OUT19/12287

**McPhillamys Gold Project (SSD 9505)
EIS Exhibition**

Attachment A

Detailed advice to DPIE Planning & Assessment regarding the McPhillamys Gold Project

Figure 35 Comparison of Recorded and Modelled Stored Water Volume in Lake Carcoar

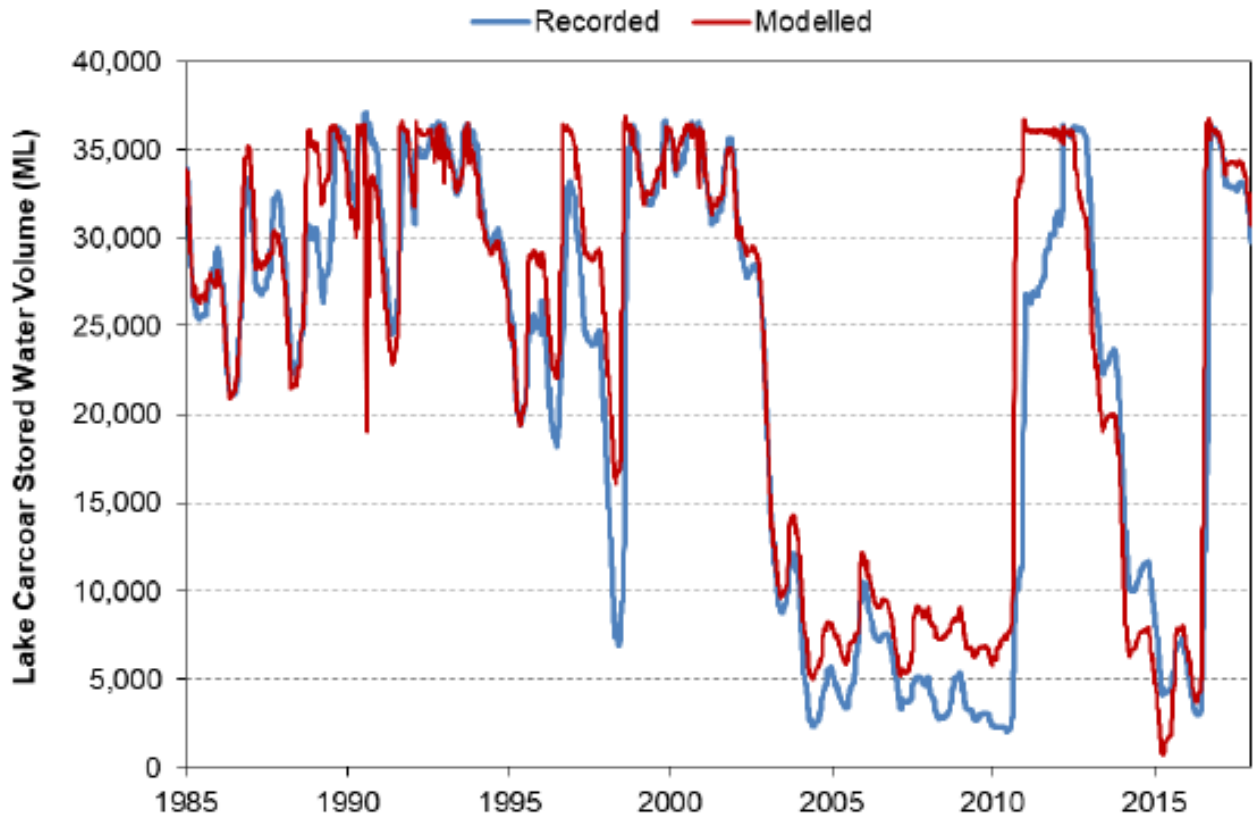
Regis Resources has developed a runoff-flow model, using the Australian Water Balance Model platform to derive site water balance, catchment runoff and river flow outputs. This includes a modelled flow input graph for Carcoar Dam, which differs significantly to recorded storage volumes at recession limb and low storage level conditions, such as during the Millennium Drought. The divergence between modelled storage volumes to monitored storage volumes is shown in Attachment B (Figure 35, Attachment J of the EIS).

An explanation about this divergence is not given in the EIS. DPIE Water is concerned that the modelled flow input is not effectively simulating actual inflow situations. Given the small size of Carcoar Dam it is important that further work is undertaken on the surface water model so that predicted impacts and mitigation options are better understood.

The base case modelled storage volume produced by the AWBM model is shown below from Figure 35 of Appendix J of the Environmental Impact Statement. The modelled inflows to storage reliability significantly diverges to both drawdown levels from 1995 onwards and storage recovery levels (eg. 2011, 2016).

- Provide DPIE Water with the input data to the AWBM model and model sensitivity runs to see if specific input variables are sensitive to outputs and comparisons between the AWMB model and DPIE Water's Source model for the Belubula River.

- Remodel the impacts on flow transmission downstream of the mining disturbance zone to Carcoar Dam to include sensitivity analyses of input variables to the AWBM model used for water balance and flow response through all stages of mining development and post-mine landform and drainage formation.

- Revise the flow reduction predictions to Carcoar Dam based on sensitivity analyses of river flow impacts to Carcoar Dam.
- Provide a full account for flow interruptions and/or flow reductions contributing to Carcoar dam based on annual flow levels to all flow year scenarios included in the AWBM model based on the maximum 5% interception of catchment runoff contribution to river flows into Carcoar Dam, using 2016-17 as a wet year sensitivity run and 2017-18 as dry year.
